ITEM FOR ENVIRONMENTAL BOARD AGENDA

NAME & NUMBER
OF PROJECT: OVERLOOK AT DAVENPORT
SPC-2012-0425C

REQUEST: Variance request is as follows:
1. To allow fill greater than 4 feet not to exceed 9.2 feet
Lake Austin Watershed Ordinance Section 9-10-409(a)

SUBJECT: Overlook at Davenport – SPC-2012-0425C

Fill Exhibit

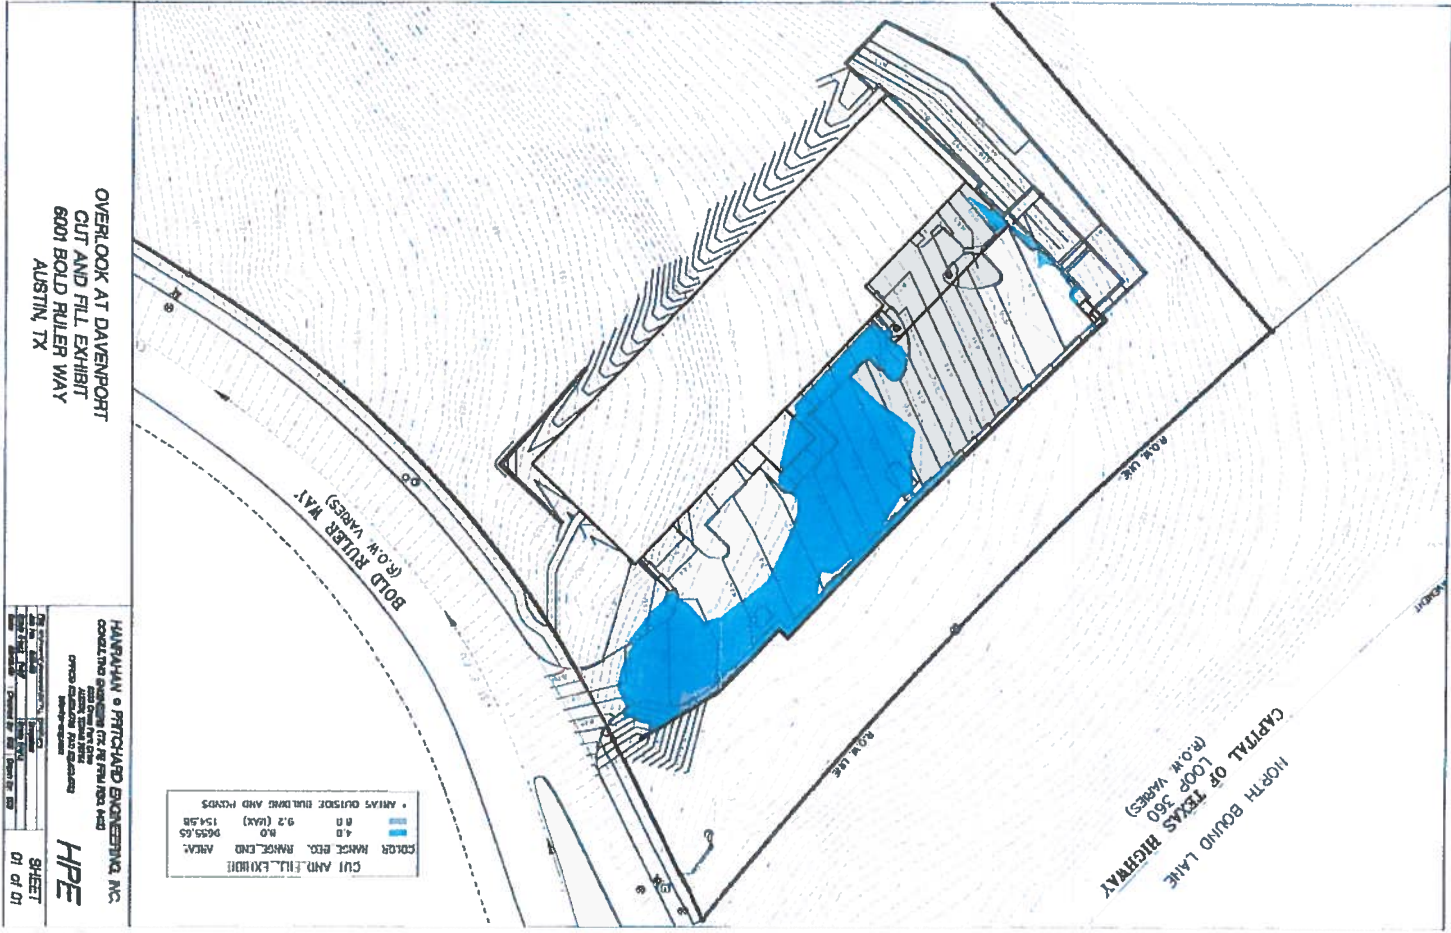
On the October 16th agenda is a request for the consideration of one variance from the Lake Austin Watershed Ordinance (840301-F), Section 9-10-409(a) - To allow fill greater than 4 feet not to exceed 9.2 feet.

1. Are there special circumstances applicable to the property involved where strict application deprives such property owner of privileges or safety enjoyed by other similarly situated property with similarly timed development? **YES**
The site's topography dictates the location and slope of the driveway which can be readily accessed and traversed. No points of access to the site provide a better driveway location than that shown on the site plan. The access street has a running slope of 17%. Strict application would deny access to the site, particularly for emergency vehicles. The Davenport West PUD prohibits access to this site from Loop 360. The applicant has also worked with the neighborhood Association and their concerns about not accessing from Canonero Drive which would be the only other possible access street. This would not be practicable as the drive would require greater overall disturbance and would be located over a greater area of slopes in excess of 15%.

2. Does the project demonstrate minimum departures from the terms of the ordinance necessary to avoid such deprivation of privileges enjoyed by such other property and to facilitate a reasonable use, and which will not create significant probabilities of harmful environmental consequences? **YES**
The affected area has been limited to the greatest extent feasible and the proposed driveway grade and cross slope meets the minimum requirements of the fire department for emergency vehicle access. The driveway cannot be placed any closer to Loop 360 as the associate parking cannot be built within the Loop 360/Hill Country Roadway setback buffer. While shifting it further away from Loop 360 along Bold Ruler would cause the building to be built on steeper slopes and greater disturbance to protected size trees. The proposed fill will be stabilized behind a proposed retaining wall.

The proposal does not provide special privileges not enjoyed by similarly situated properties and is not based on a condition created as a result of the way the land has been subdivided. Functional grading and drive access was designed for the project which did not require a variance, but AFD has requested modifications to allow for access to the site by the largest of their equipment, and the ability to set up and extend outriggers over a more level parking surface. The Davenport West PUD prohibits access to this site from Loop 360. The applicant has also worked with the neighborhood Association and their concerns about not accessing from Canonero Drive which would be the only other possible access street. This would not be practicable as the drive would require greater overall disturbance and would be located over a greater area of slopes in excess of 15%.

1. The remaining allowable impervious cover on this site may only be used for site plan revisions in which no additional environmental variances will be required.”

Staff recommends approval of the variance with one condition as the Findings of Fact have been met (see attached)
